Three Mile Island Unit 1
Route 441 South, P.O. Box 480
Middletown, PA 17057
Telephone 717-948-8000

April 28, 2017
TMI-17-029

SUBJECT: COMBINED 2016 ANNUAL RADIOACTIVE EFFLUENT RELEASE REPORT

**ODCM Change for TMI
Offsite Dose Calculation Manual, Revision 4
CY-TM-170-300**

FIGURE 1.2

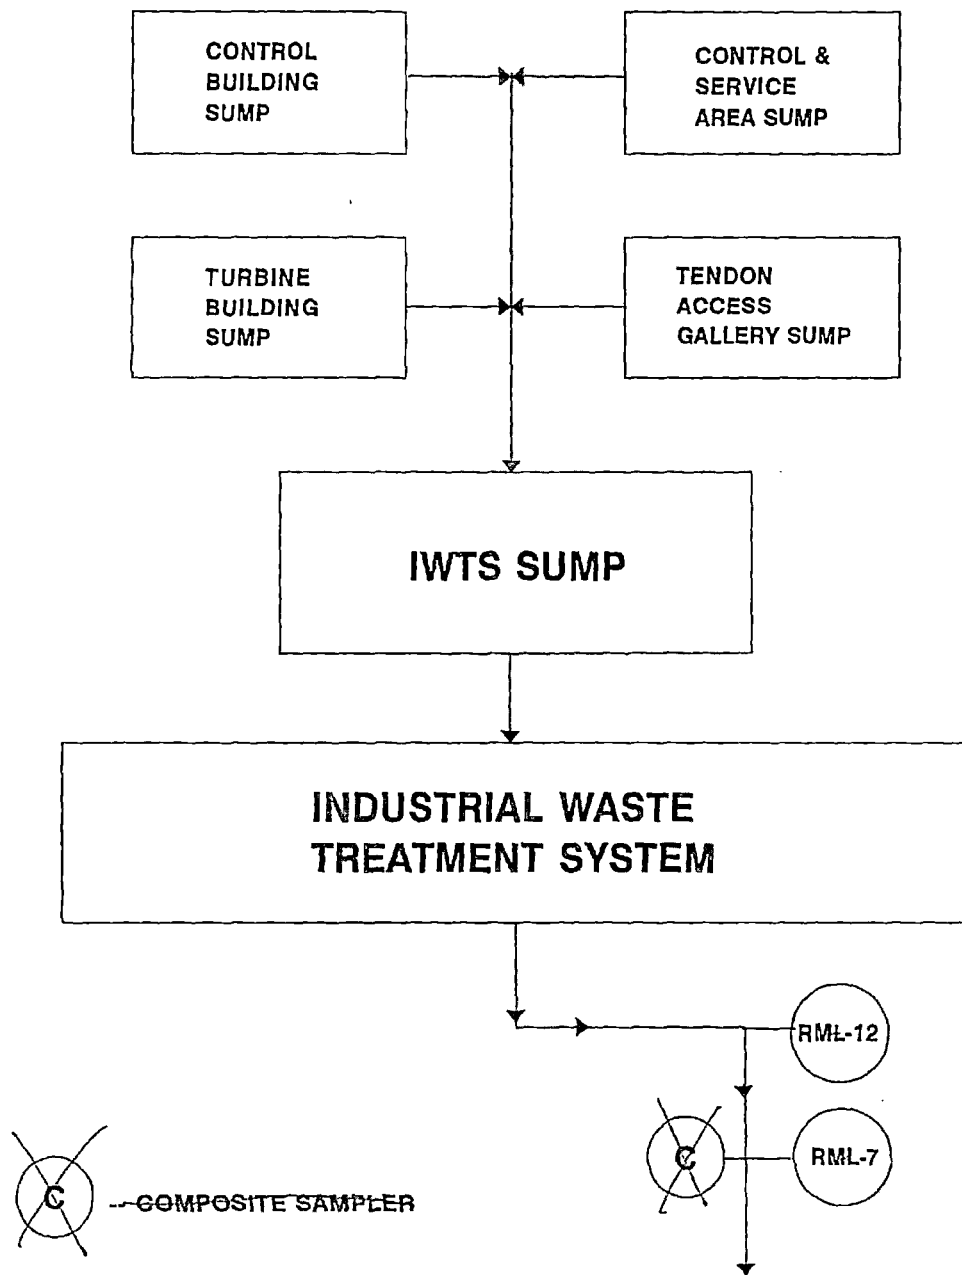
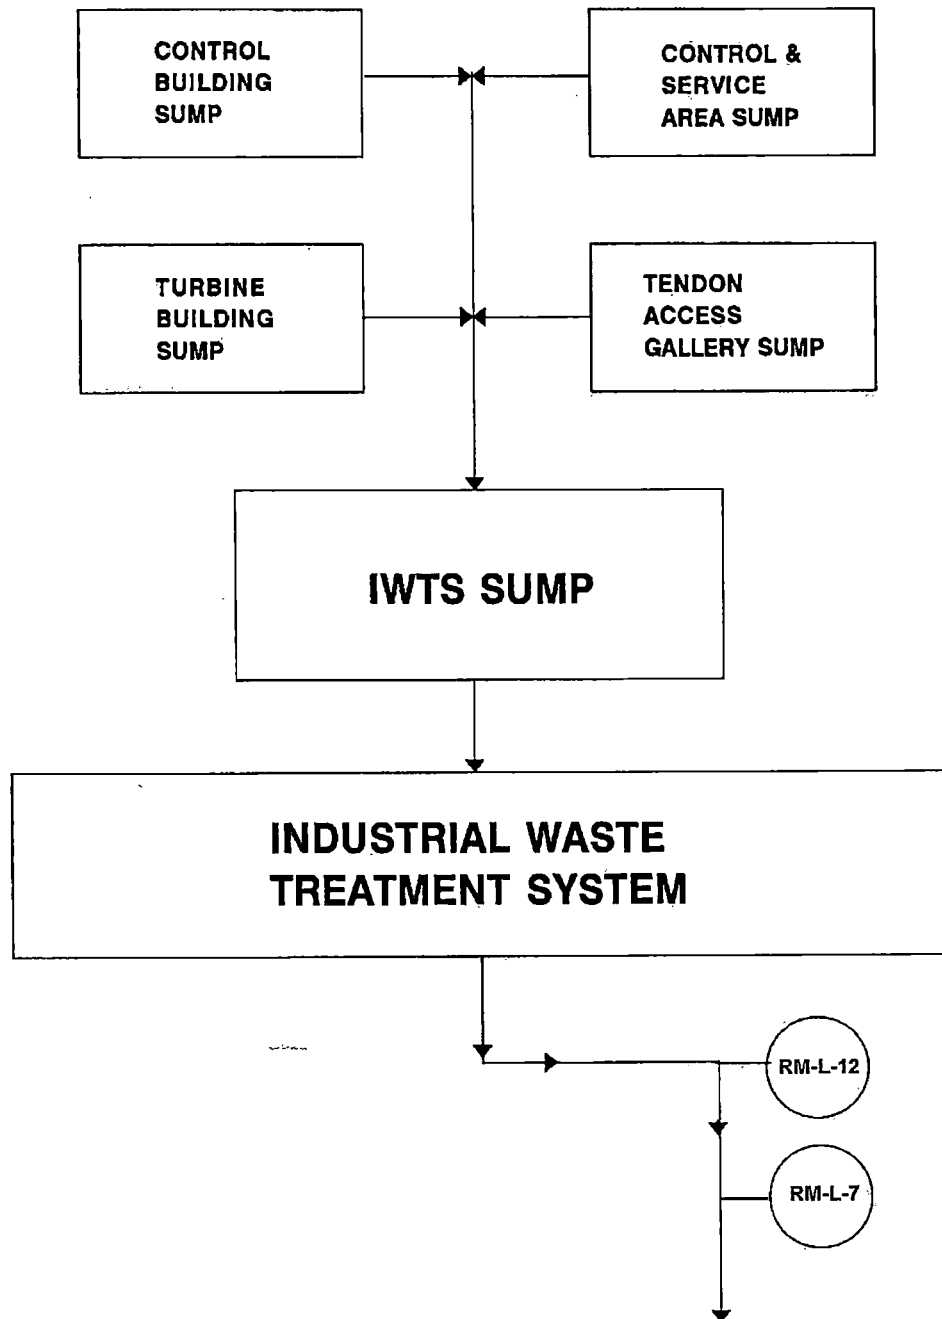
The Offsite Dose Calculation Manual (ODCM) is being changed for minor corrections and clarifications to Tables, Figures and Maps to improve human performance. Updating Figures 3.1 and 1.2 will have the figures reflect the current configuration in the plant. Updating the meteorological data to more current information will improve the accuracy of dose calculation estimates. Maintaining consistency with the NRC NUREG 0133 guidance for equations will make it clearer to users and inspectors. These changes will not increase the dose to the public or reduce TMI's ability to control or quantify releases. There has been no impact on the intent of the ODCM.

** ~~The Water Treatment and Sludge Collection Sumps will be deactivated for PDMS.~~

FIGURE 3.1
TMI-1 Liquid Radwaste

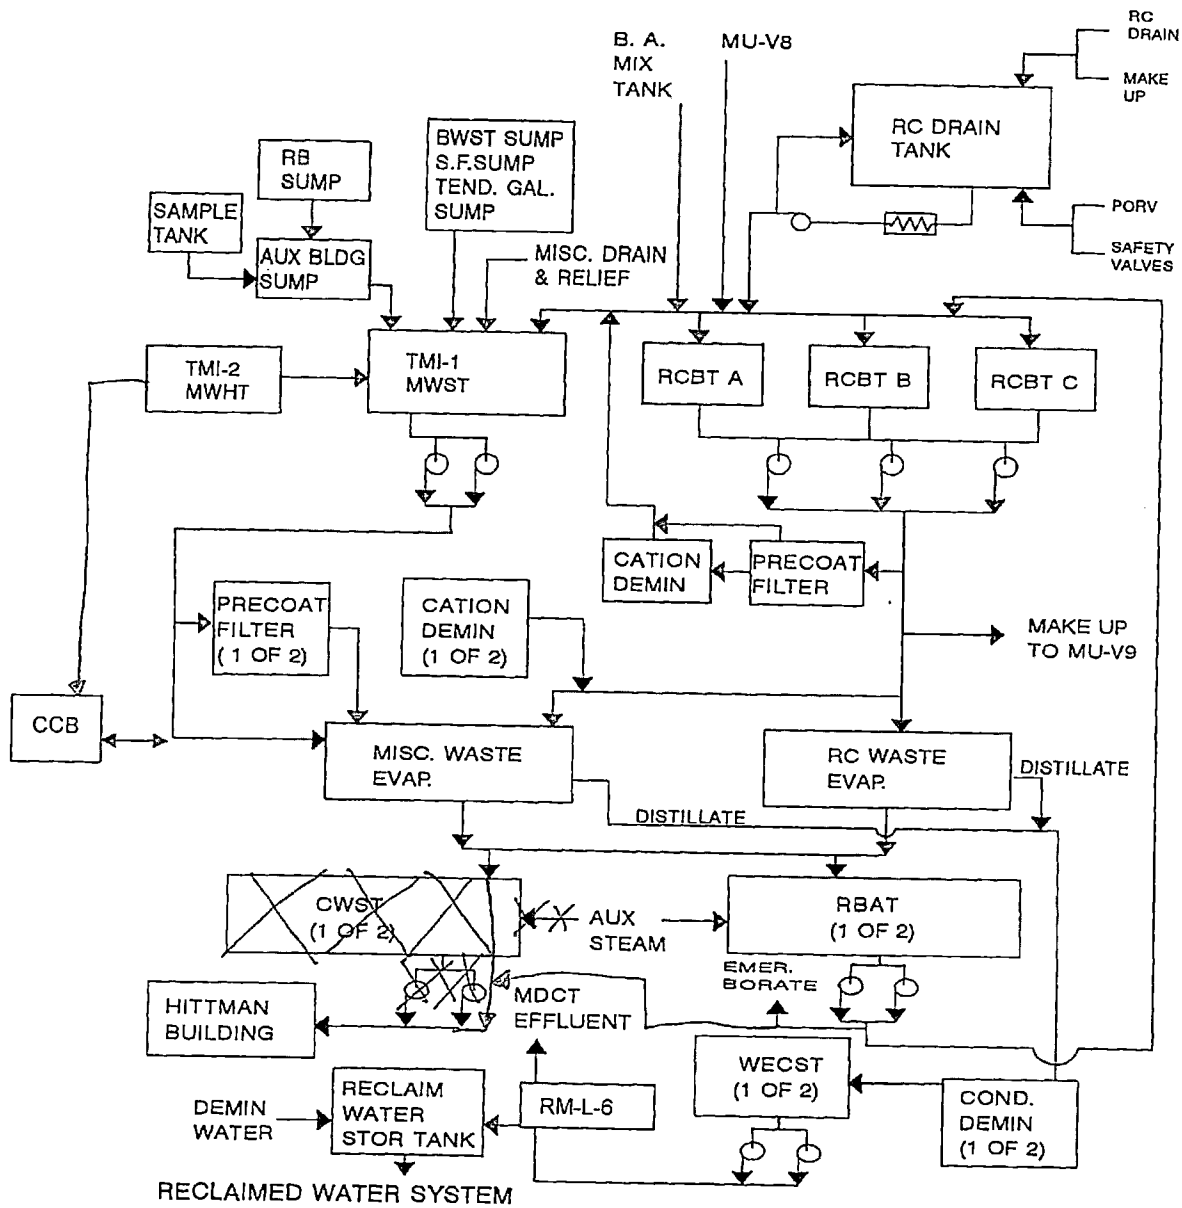
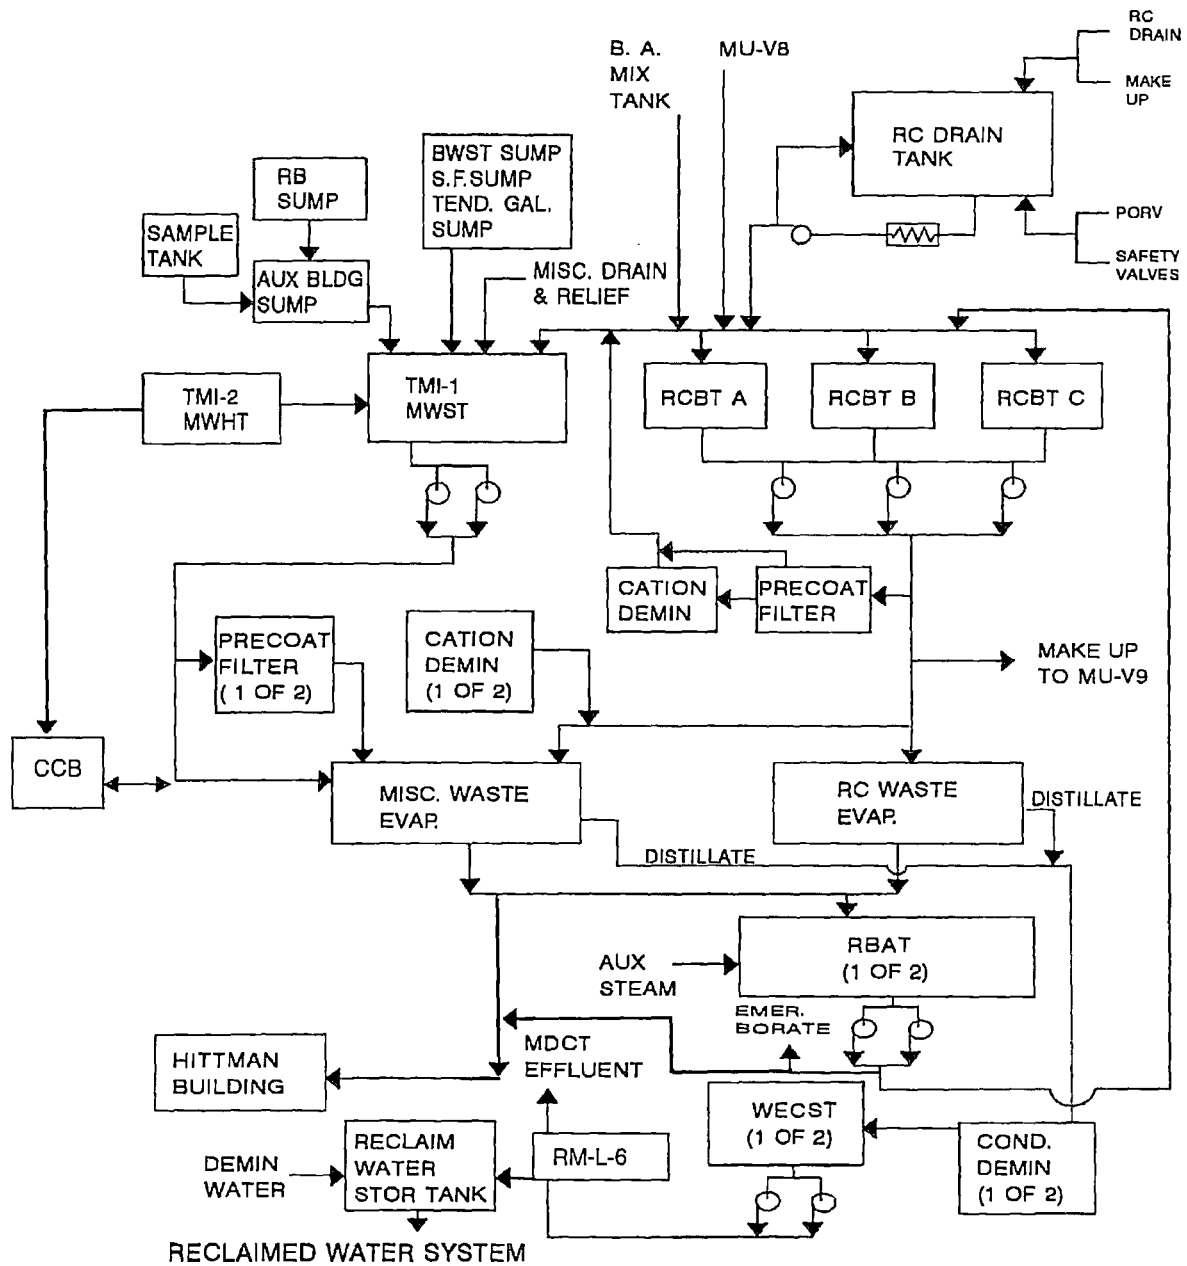
- a. Water Sources - (3) Reactor Coolant Bleed Tanks (RCBT)
- (1) Reactor Coolant Drain Tank (RCDT)
- b. Liquid Processing - Reactor Coolant Waste Evaporator
- Demineralizers prior to release
(see Figure 3.2)
- c. Liquid Effluent for Release- (2) Waste Evaporator Condensate
Storage Tanks - (WECST)
- d. Dilution - ^{Station Effluent Flow} ~~Mechanical Draft Cooling Tower (0-38k-gpm)~~
- River Flow (2E7 gpm average)

- b. Liquid Processing - Miscellaneous Waste Evaporator, MWE
 - Demineralizers prior to release
(see Figure 3.2)
- c. Liquid Effluent for Release - (2) Waste Evaporator Condensate Storage Tanks- (WECST)
- d. Dilution
 - ~~Mechanical Draft Cooling Tower (0-38k gpm)~~ ^{Station Effluent Flow}
 - River Flow (2E7 gpm average)

MAP 8.1
THREE MILE ISLAND NUCLEAR STATION
LOCATIONS OF RADIOLOGICAL ENVIRONMENTAL MONITORING PROGRAM
STATIONS WITHIN 1 MILE OF THE SITE

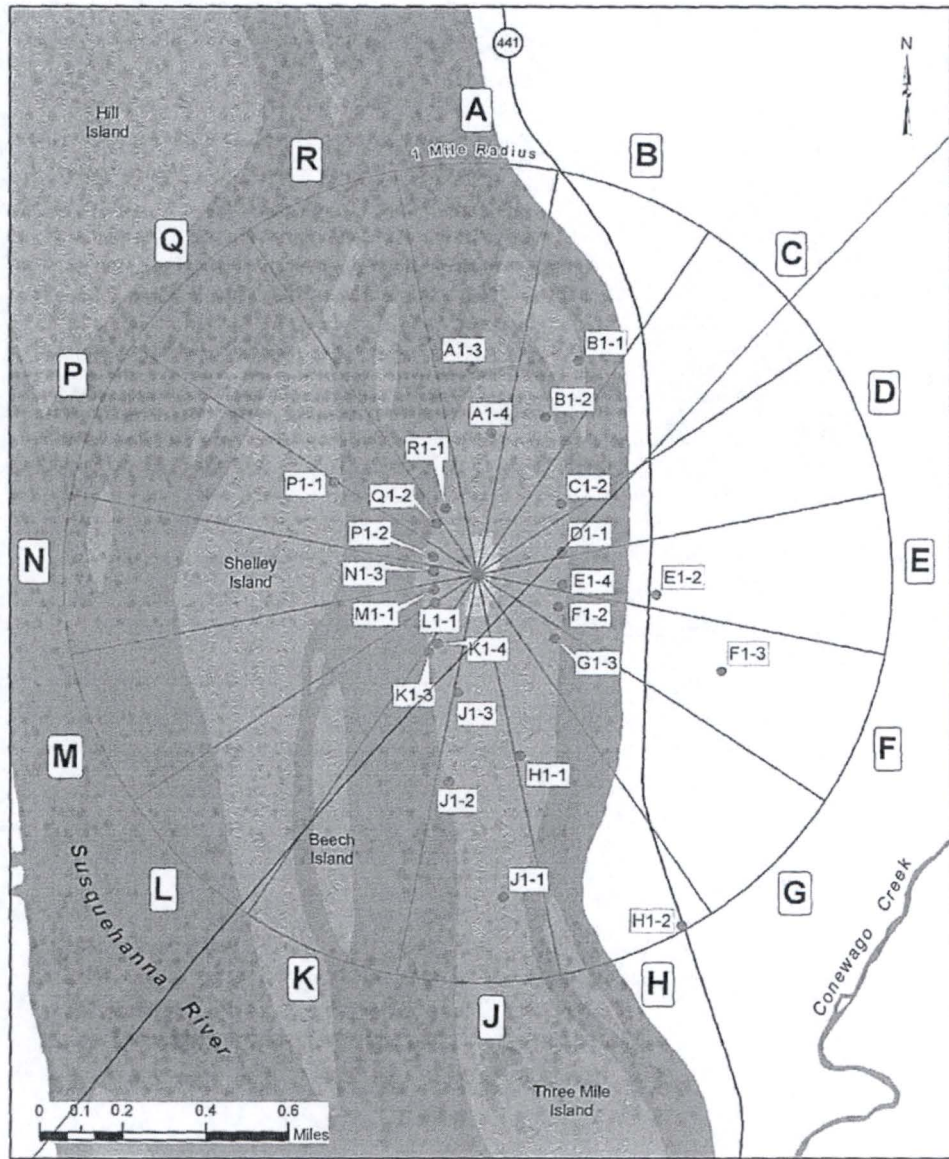
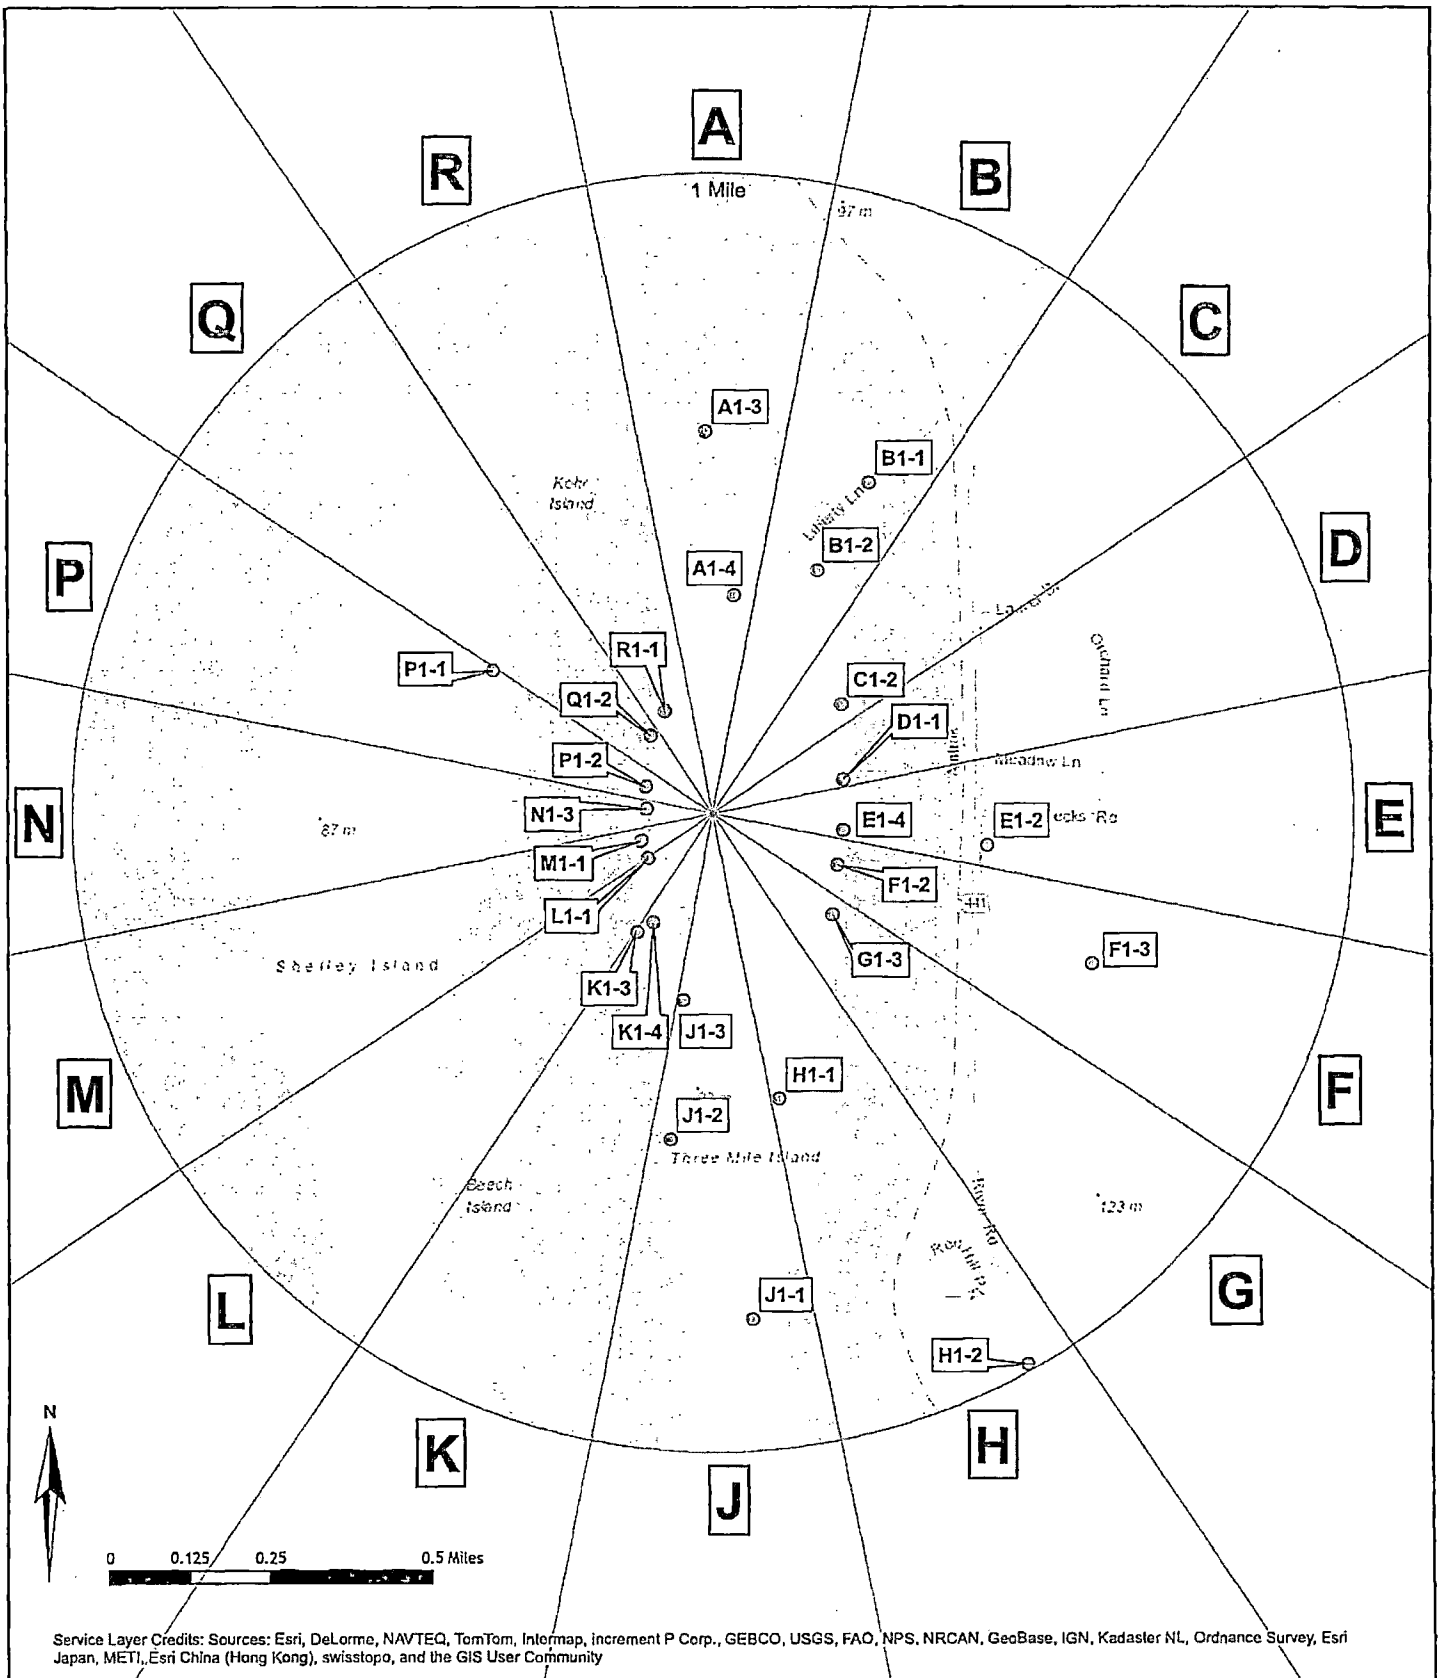
Replace with attached (file available)
